3315 LINE 34.5kV REFURBISHMENT

CONNECTICUT RIVER
CROSSING SPAN WT2-WT3

400236-C-L-01

ATTACHMENT B

CONNECTICUT RIVER
CROSSING SPAN WT2-WT3

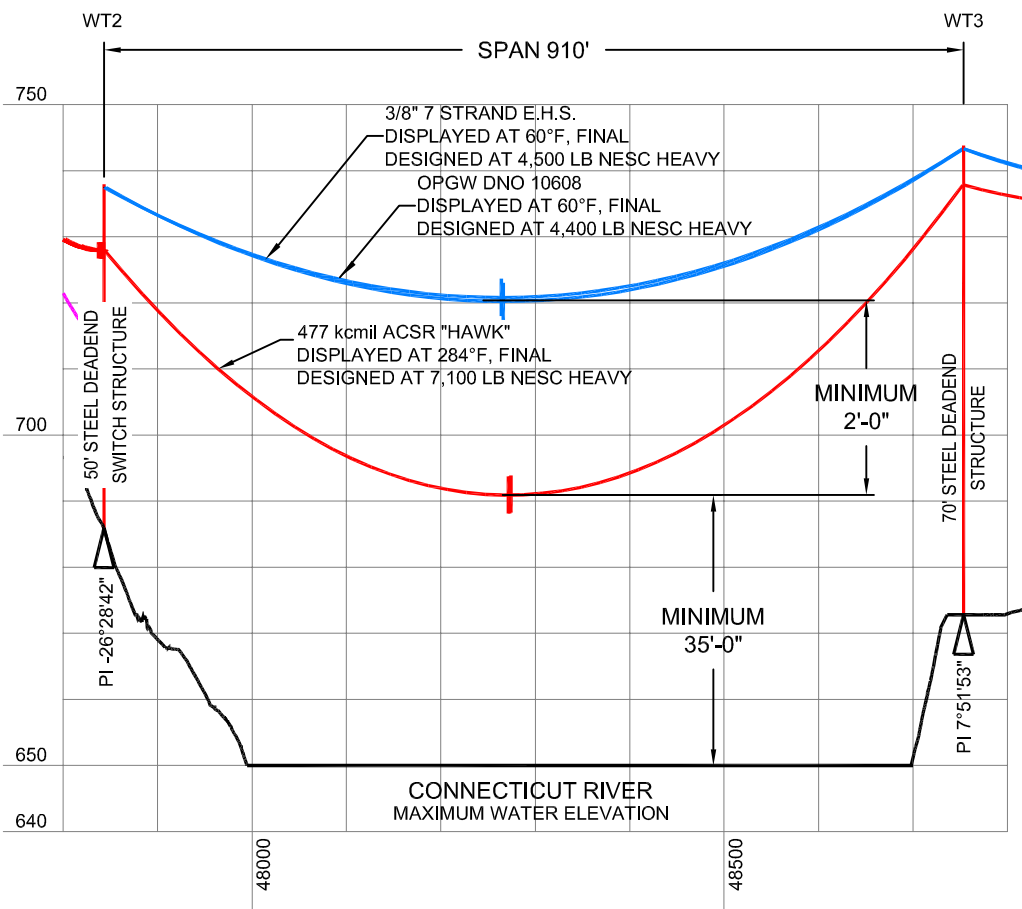
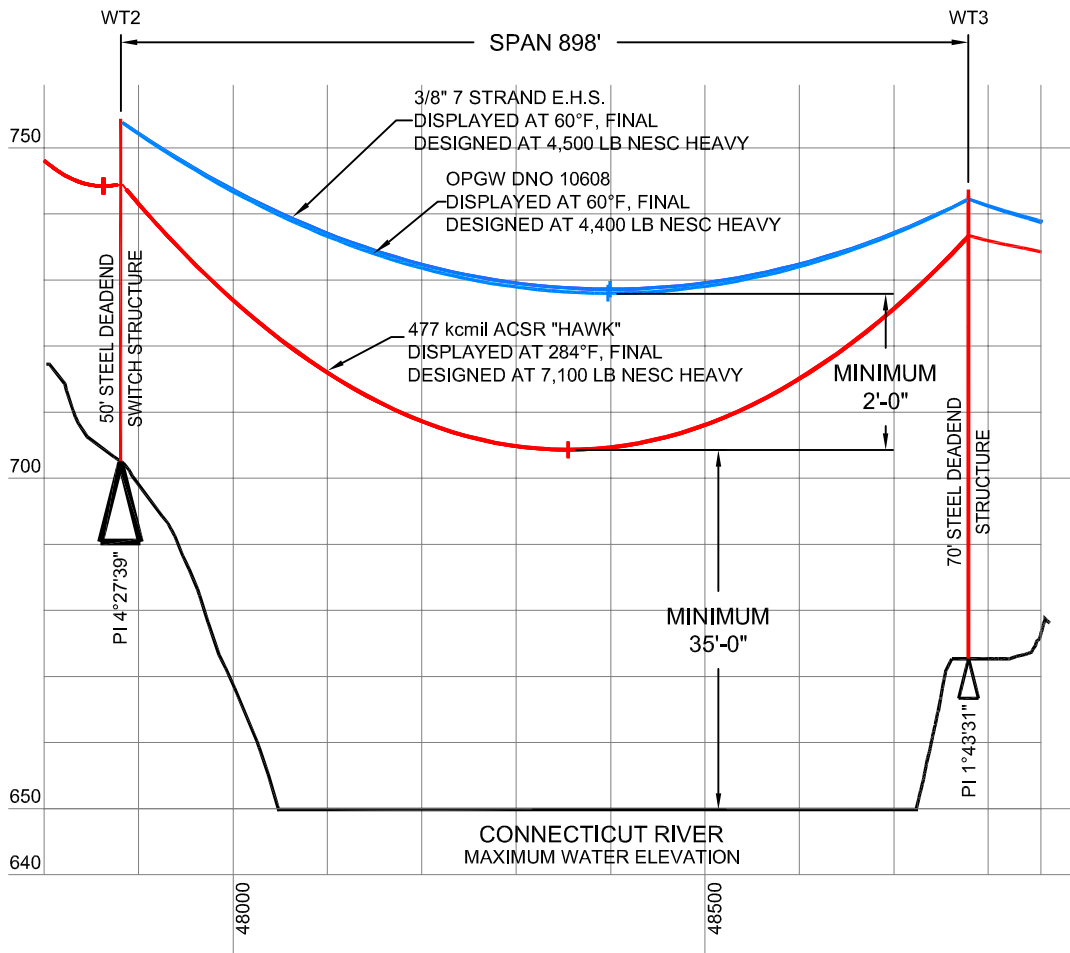
VER	DATE	VERSION DESCRIPTION	PREPARED	REVIEWED	APPROVED	VERSION
1	5/20/15	ISSUED FOR PERMITTING.	CAI/UDB	CAI/SMH	CAI/JFM	3
2	3/3/16	CHANGED LOCATION OF STRUCTURE WT2	CAI/UDB	CAI/SMH	UDB/RNC	
3	3/18/16	ADDED PREVIOUS LOCATION OF STRUCTURE WT2	CAI/UDB	CAI/SMH	CAI/RNC	
4
